FO81J, K, S; FO8L9
BCTS Foghorn VIA
 prepared by
RDI Resource Design Inc
October 26, 2015

VNS Simulation of Landforms and Visual Sensitivity Units

Visual Impact Assessment Summary Table

Sandbox original without RDI Leave. Existing nonVEG in orange

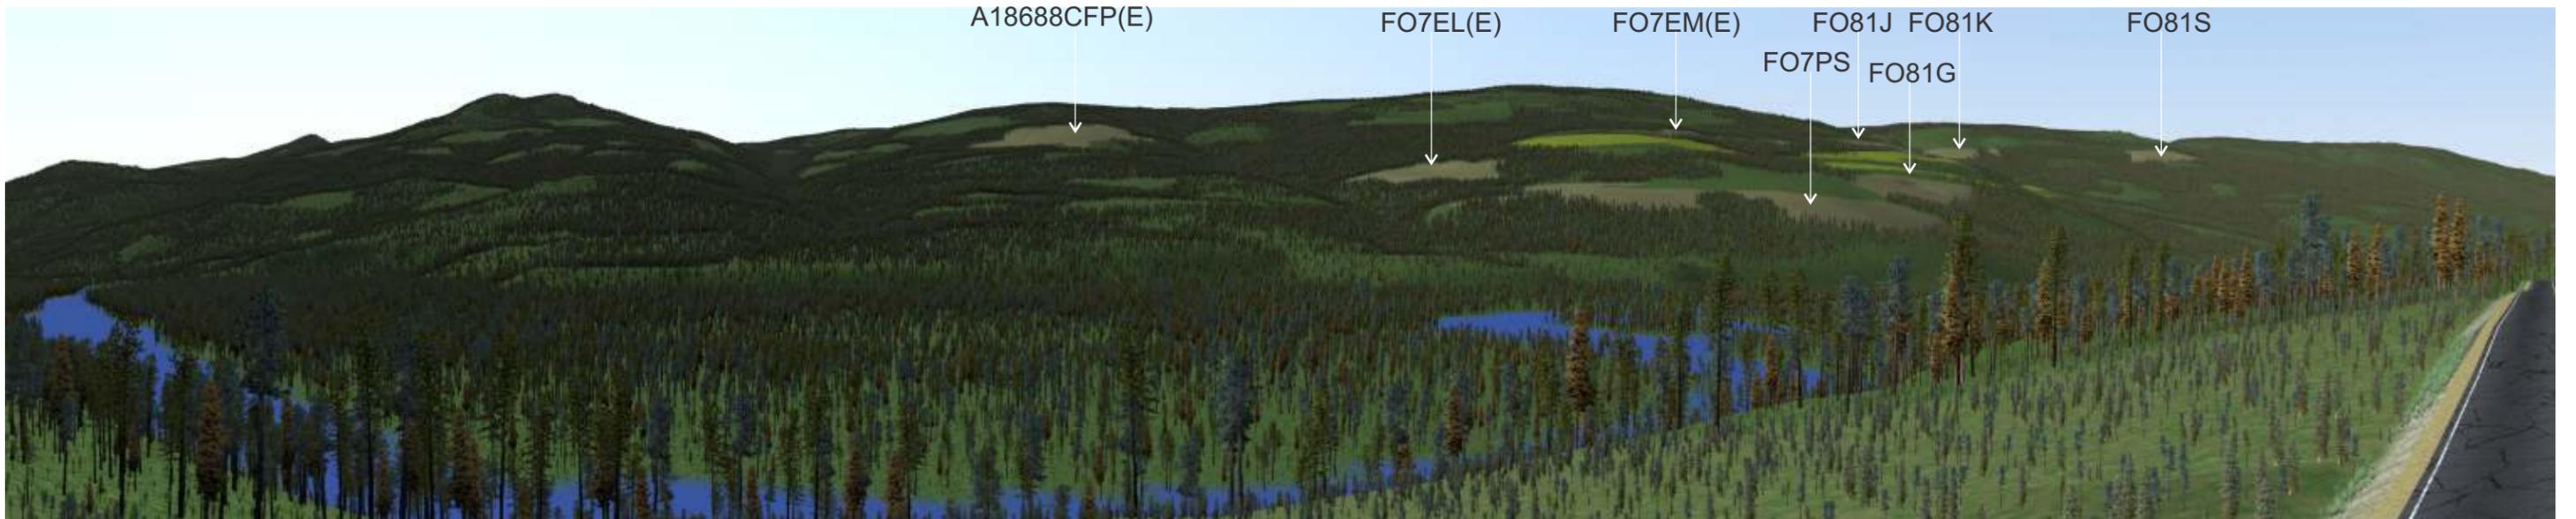
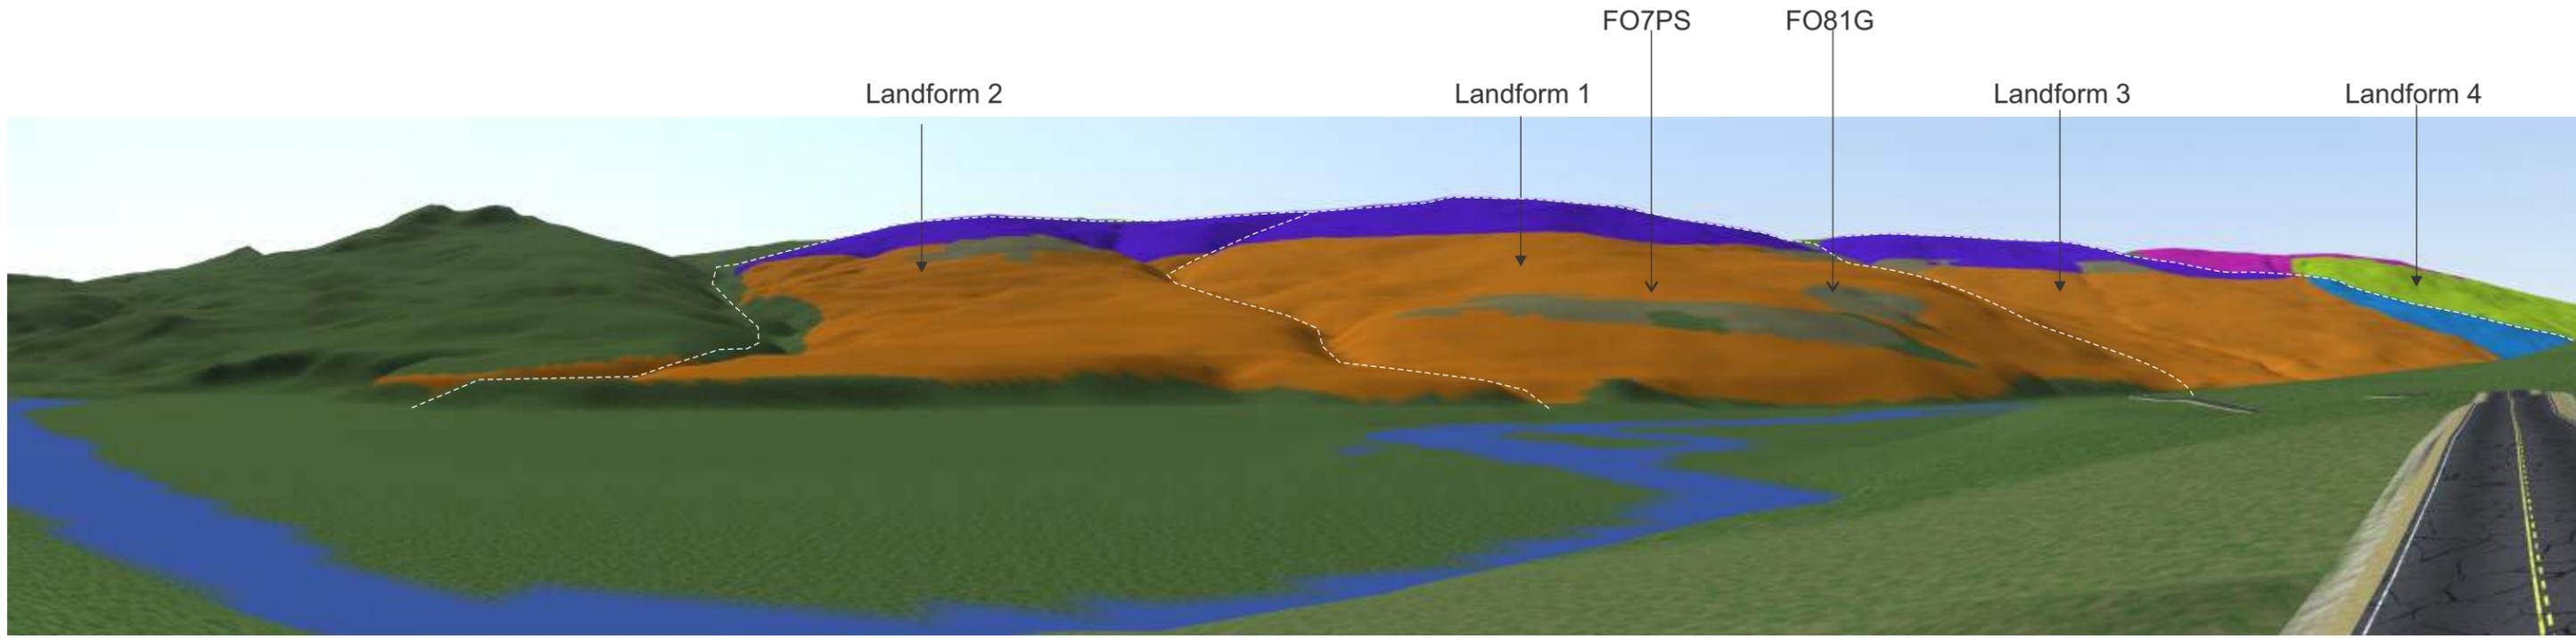
Sandbox Viewpoint VNS Simulations with RDI Leave Recommendations

Sandbox with RDI Leave. Existing nonVEG in light green.

McCorvie original without RDI Leave. Existing nonVEG in orange

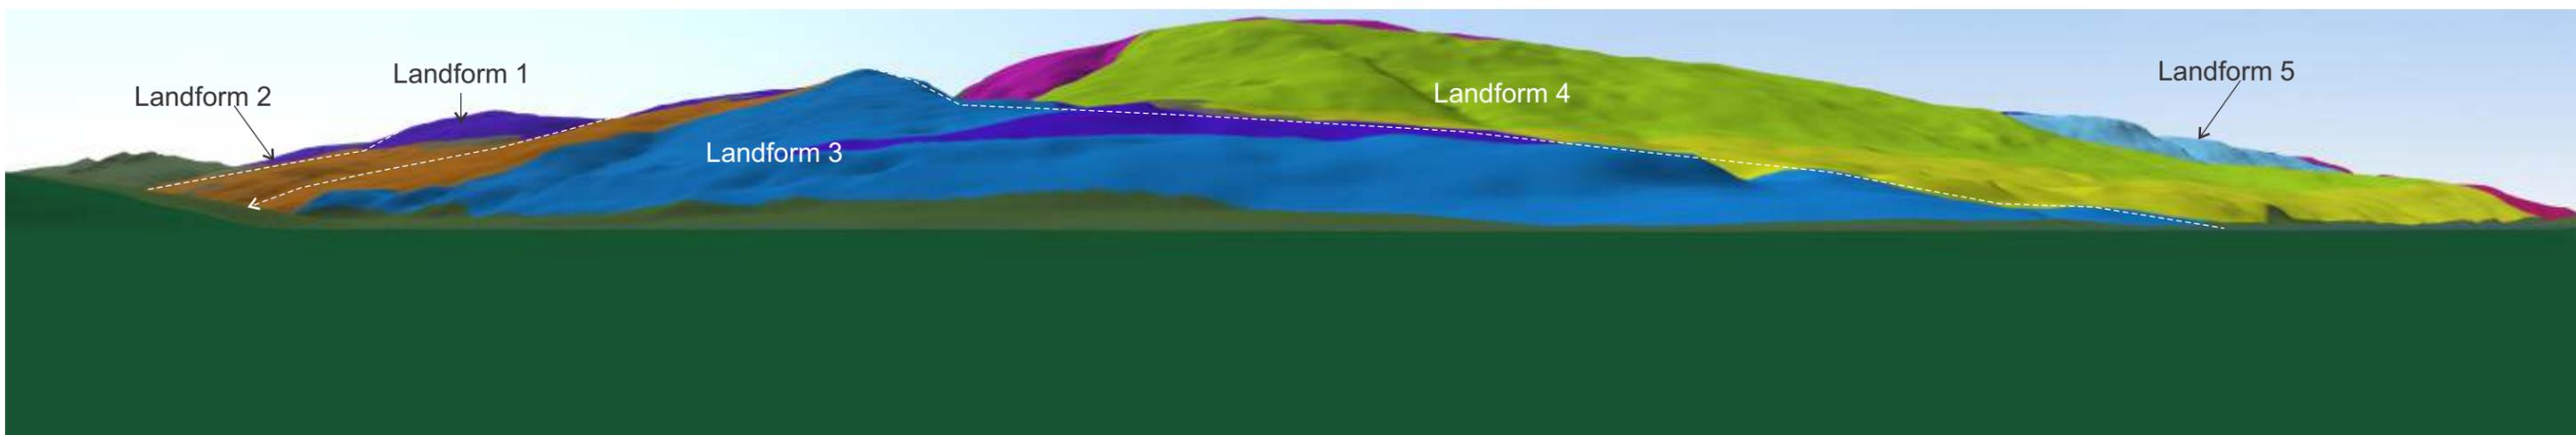
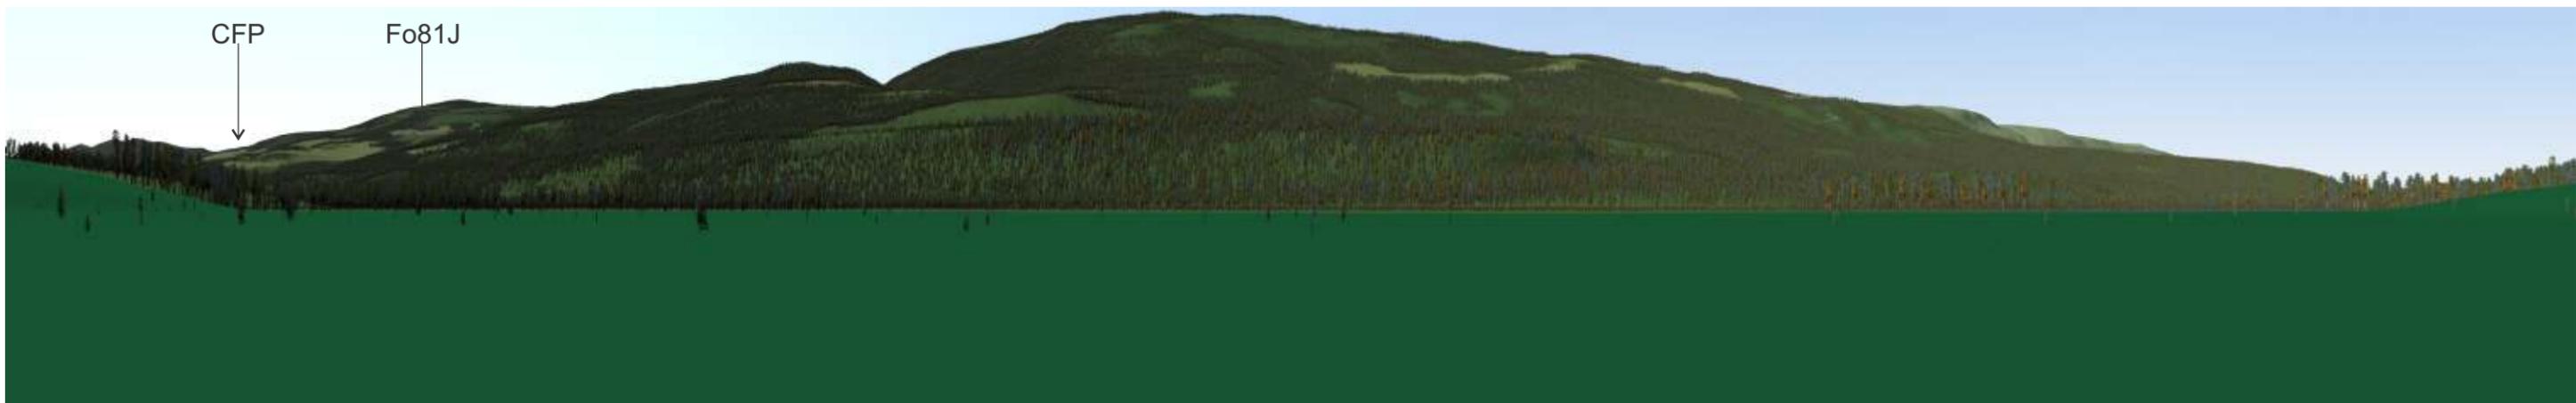
*Overall, yes, but the hard angle forming the northwest corner of FO7PS is obvious travelling east on Highway 5 (McCorvie Viewpoint). Although the blocks can achieve the definition of Modification, RDI considers it to be preferable to reduce the angularity by the addition of a total of 8 ha of retention patches as suggested by RDI. Field confirmation of operability considerations is necessary. See Assessing Scale of Alteration for a discussion about scale as influencing the verbal definition of Modification and the need for or desirability of making the adjustments suggested by RDI.

McCorvie with RDI Leave. Existing nonVEG in light green.
